Architect's Supplemental Instructions

Architect's Project No: 04561.01
Architect's ASI No: 040

Project:
Webster University
Interdisciplinary Science
Building

Date Issued: 12/09/2016

A0508.C

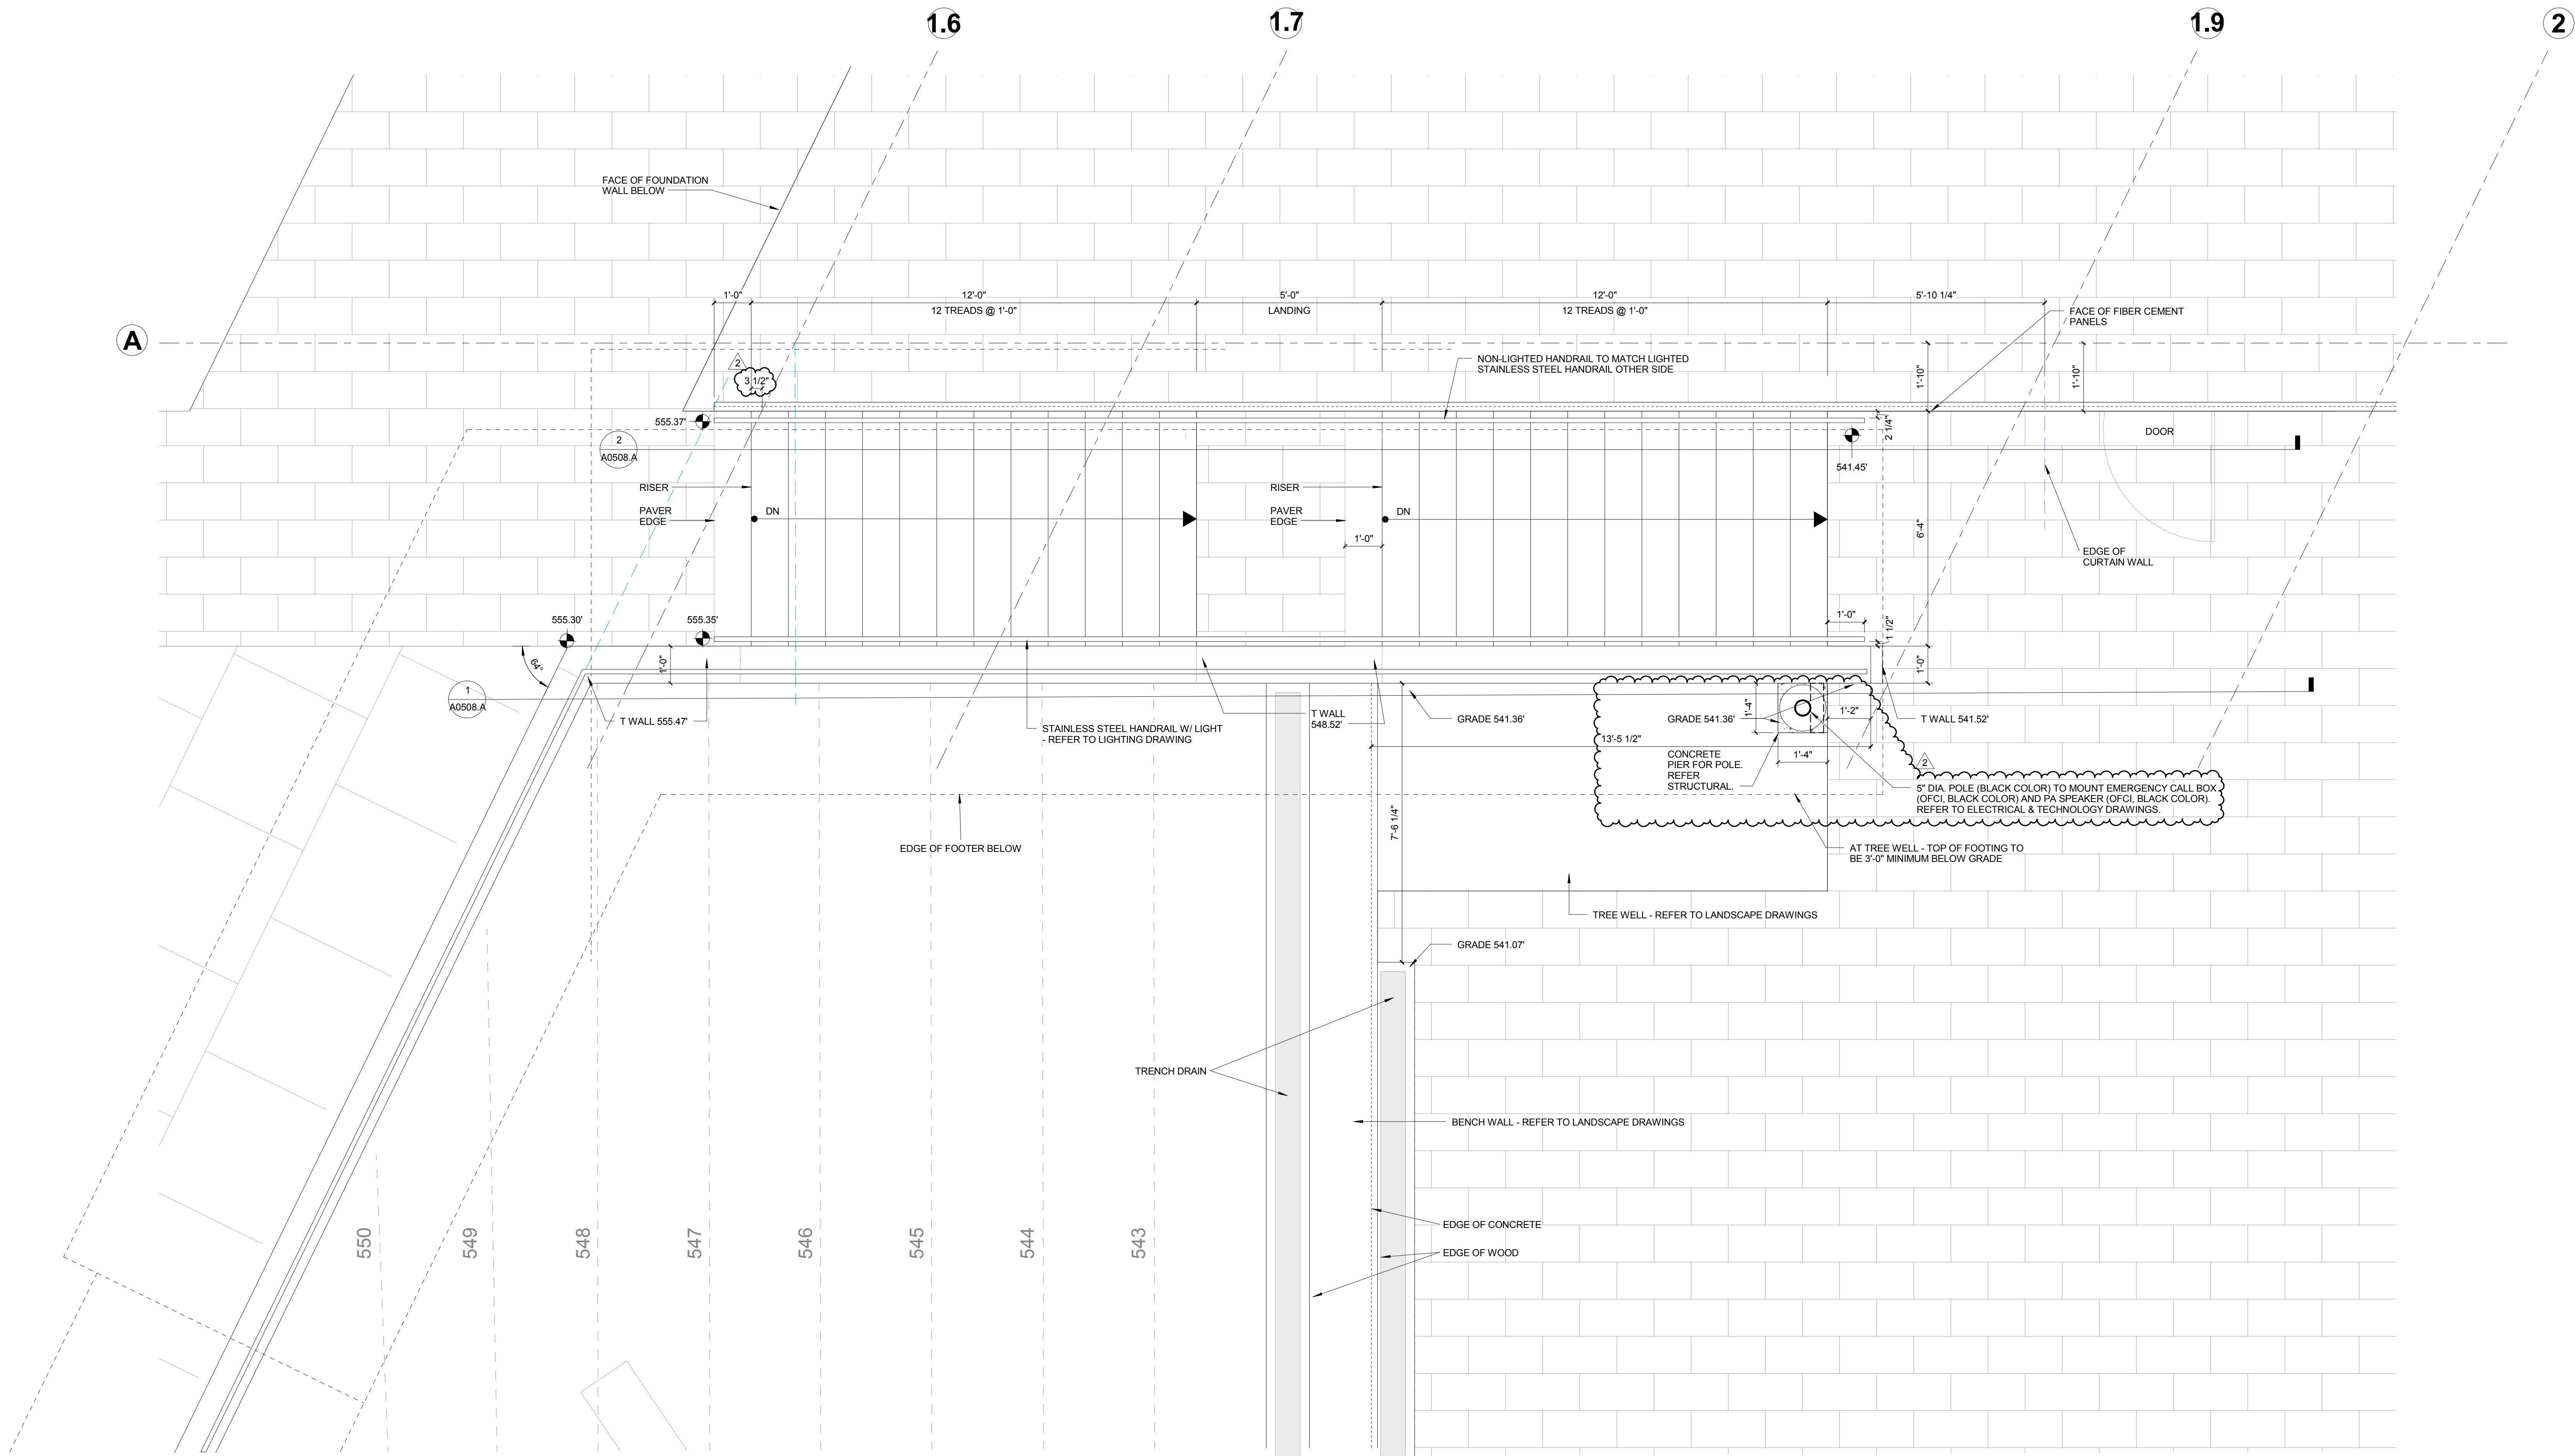
1. S0003 – TYPICAL DETAILS
 - A. Detail 4 – ADD concrete pier in courtyard for post supporting speaker.
2. A0508.C – COURTYARD WALLS & STAIRS – NORTH
 - A. Added pole to mount 'Emergency Call Box' and 'Outdoor PA speaker'.

M0401

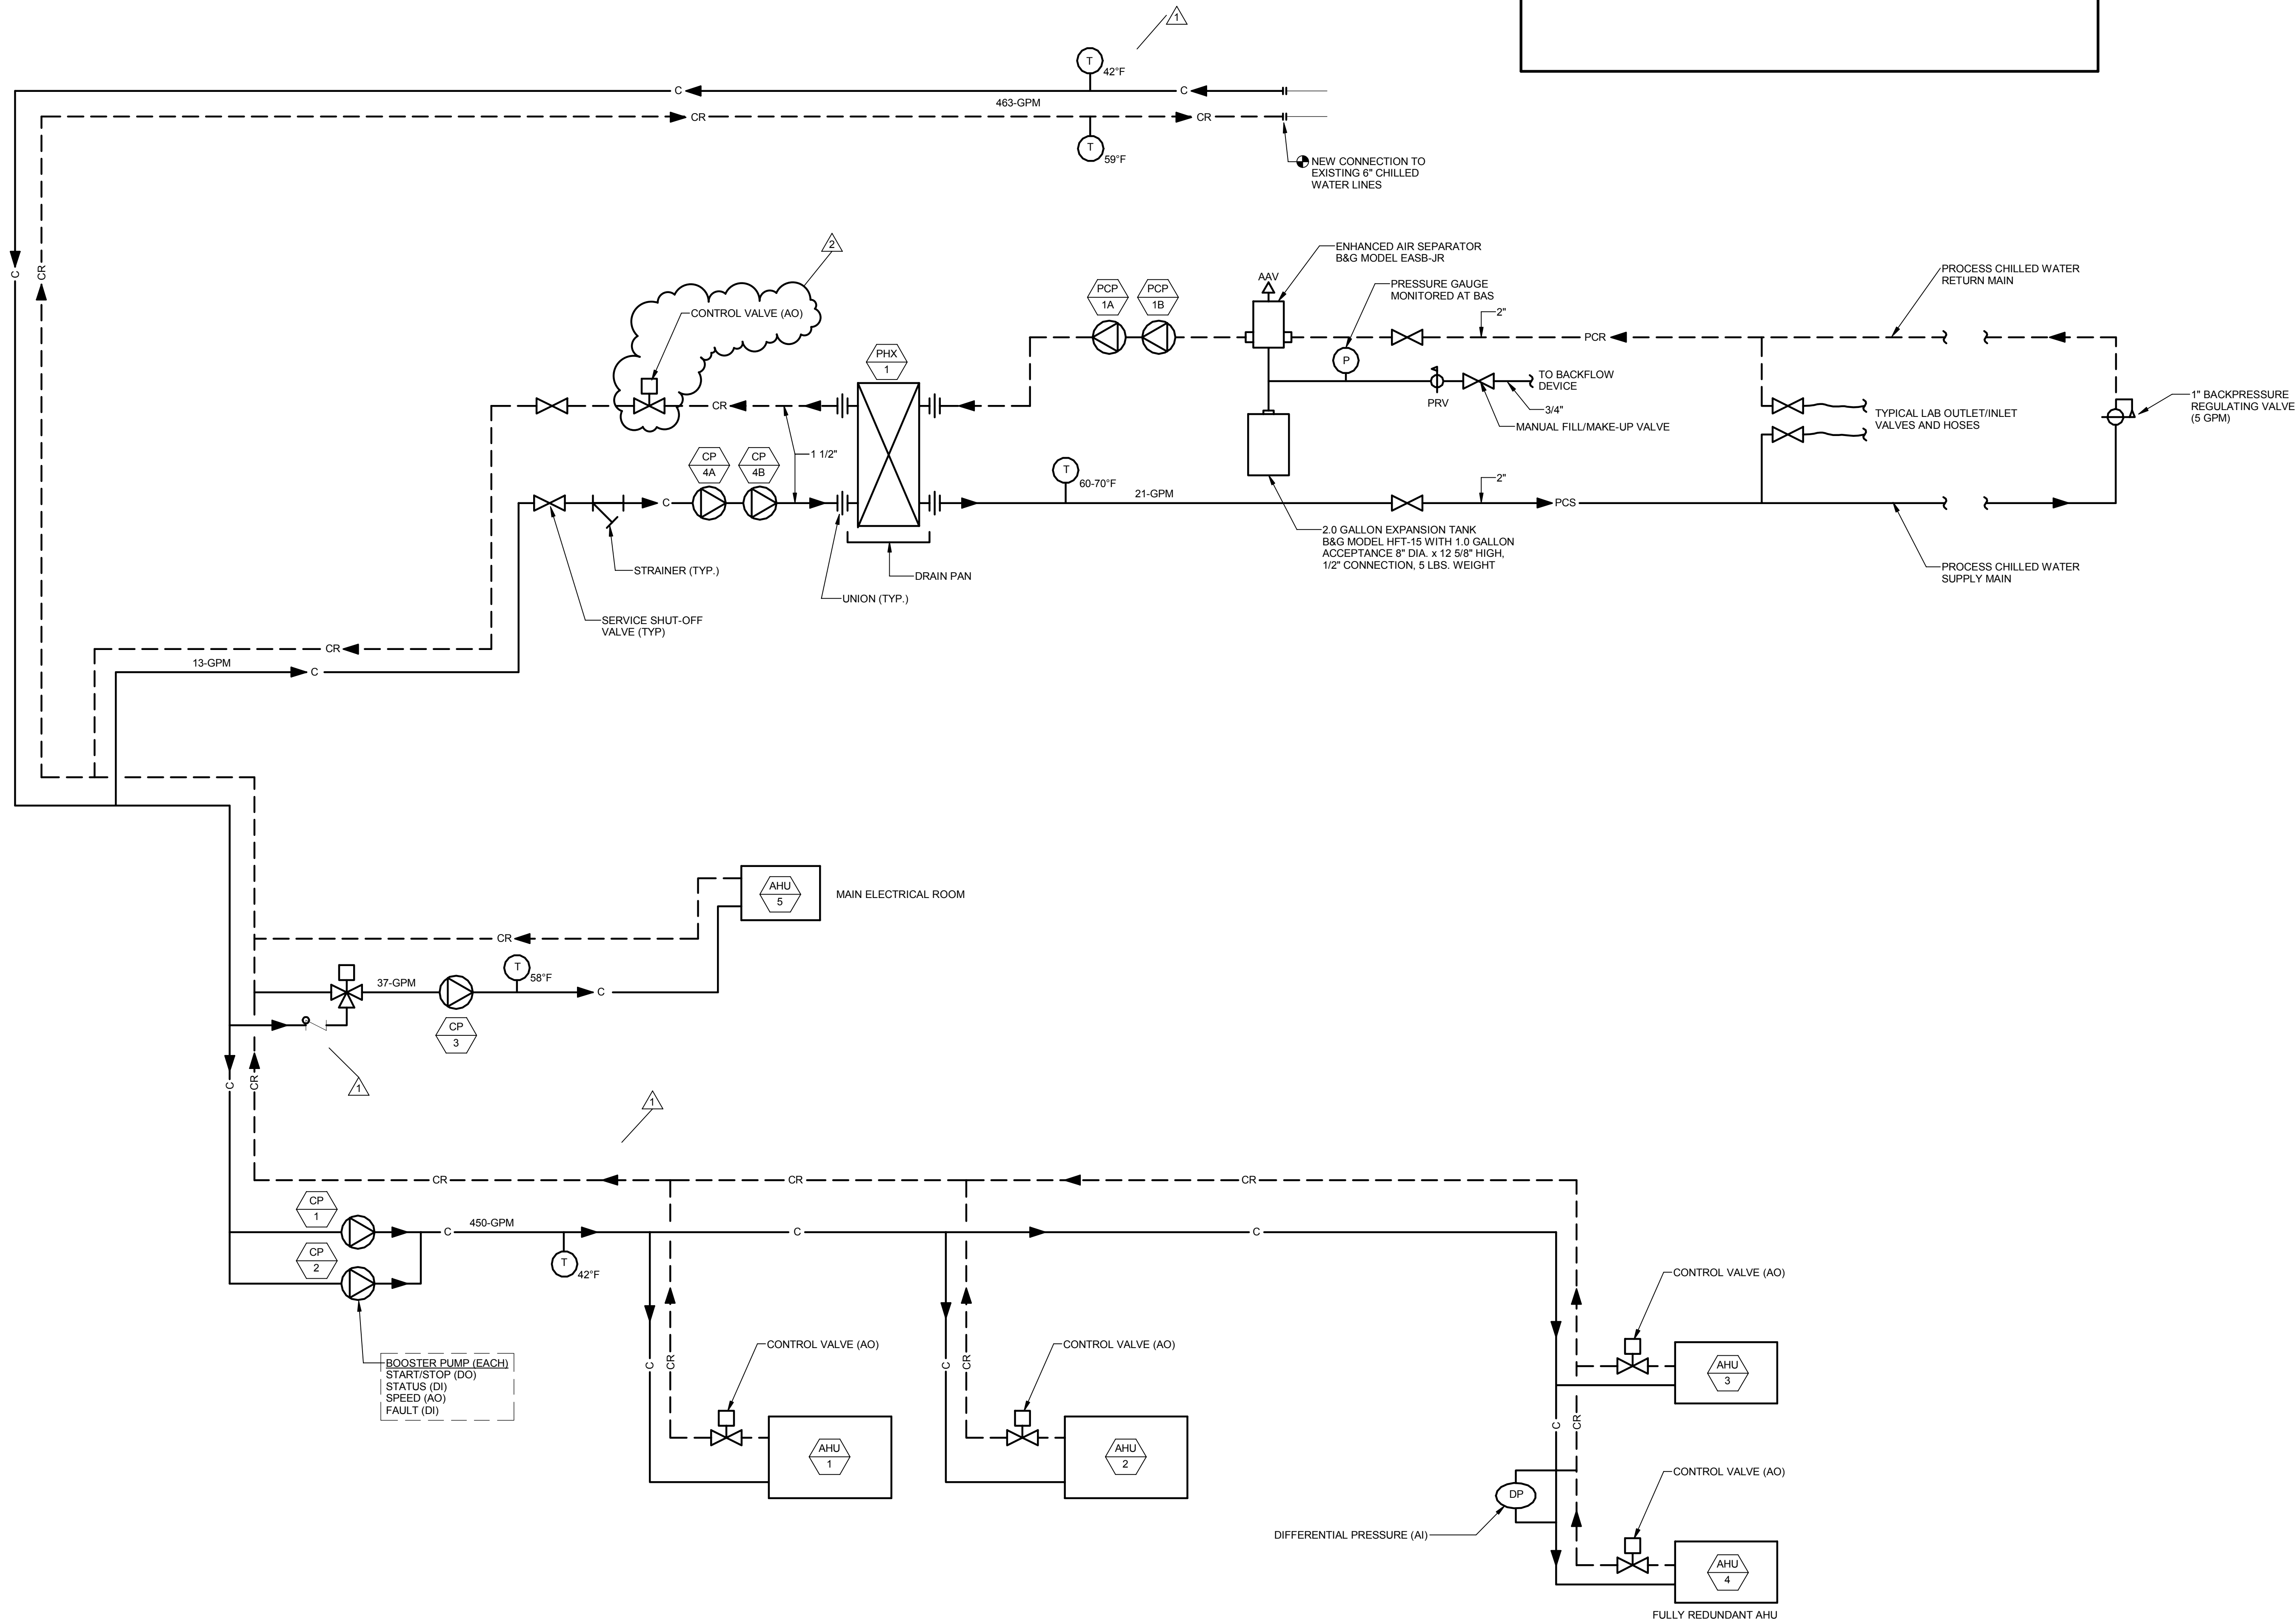
- D. Coordinate pole pre-drilling locations with owner provided equipment.
4. M0401 – DIAGRAM - MECHANICAL
 - A. Add a 2-position control valve at HX-1 as shown on piping diagram.

T0101.A

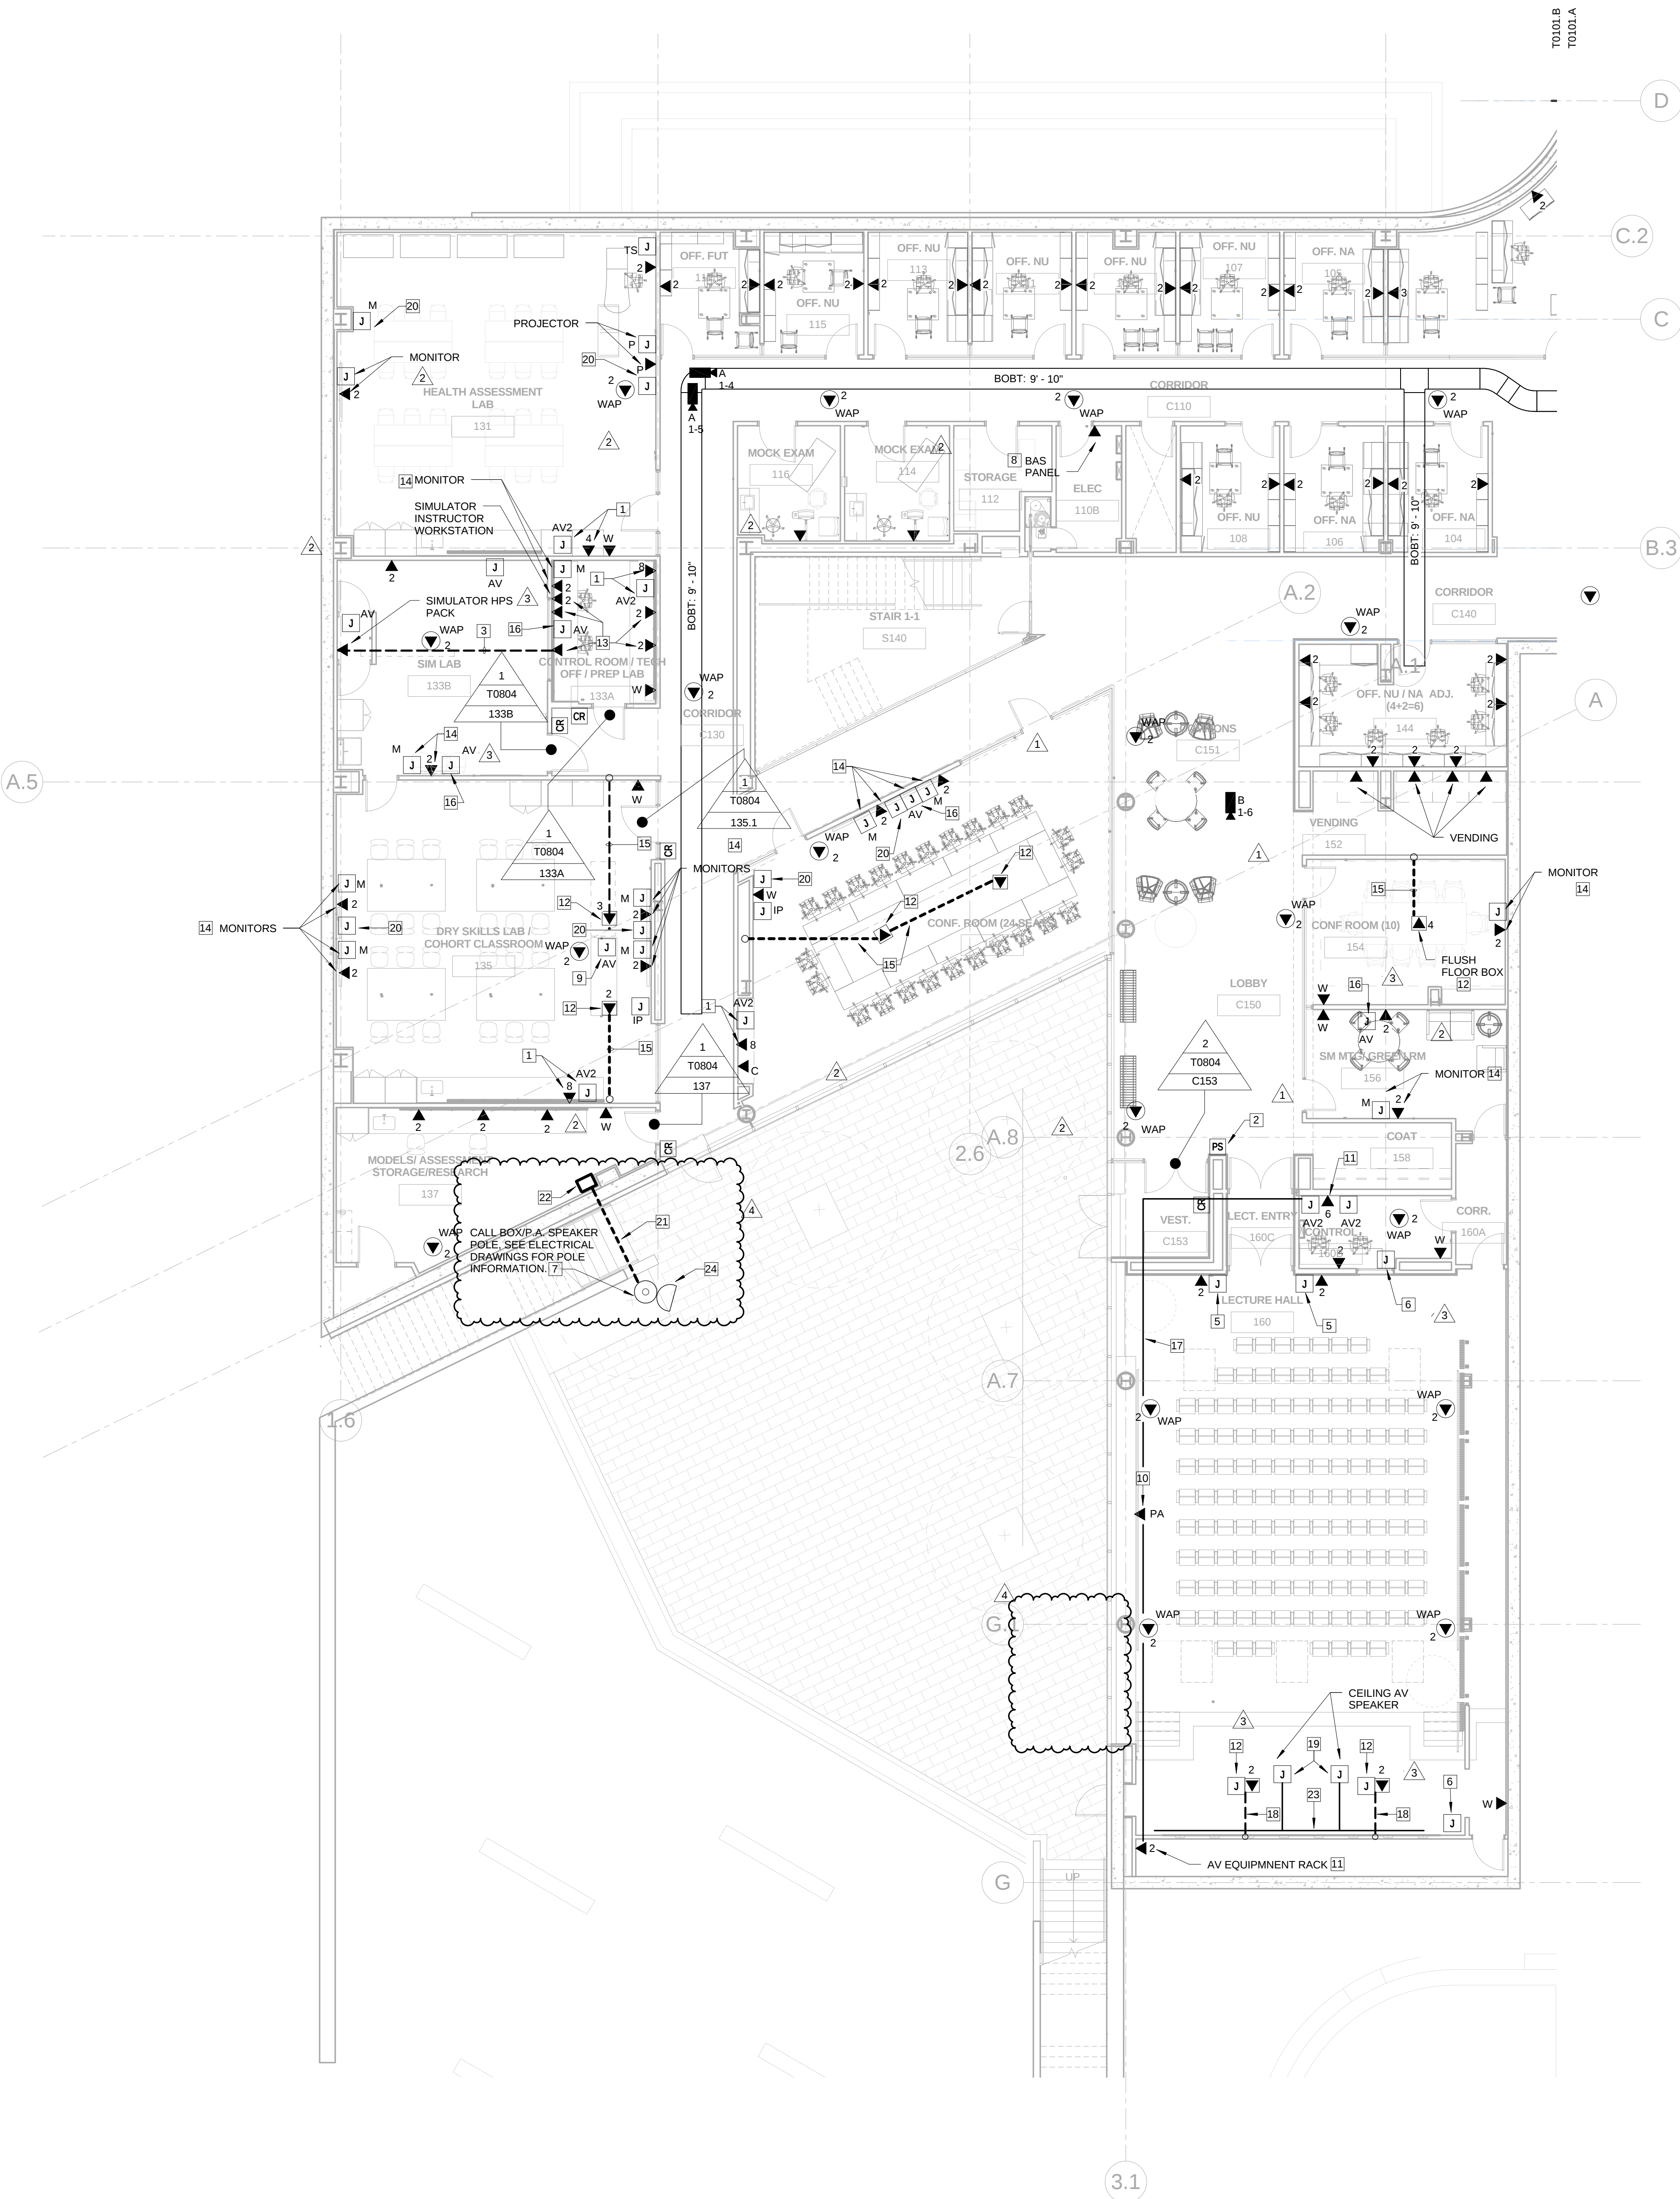
5. T0101.A – LEVEL 01 FLOOR PLAN – AREA B
 - A. Moved PA location from wall to ceiling.
 - B. Revised keyed note 13 to reflect this change.
6. T0101.B – LEVEL 01 FLOOR PLAN – AREA B

13. COORDINATE EXACT LOCATION WITH PA INSTALLER.
14. MOUNT AT LIGHT SWITCH HEIGHT.
15. MOUNT AT RECEPTACLE HEIGHT. PROVIDE (1) 1" CONDUIT UP TO "IP" BOX (SEE KEYED NOTE 14). CENTER DIRECTLY BELOW "IP" BOX.
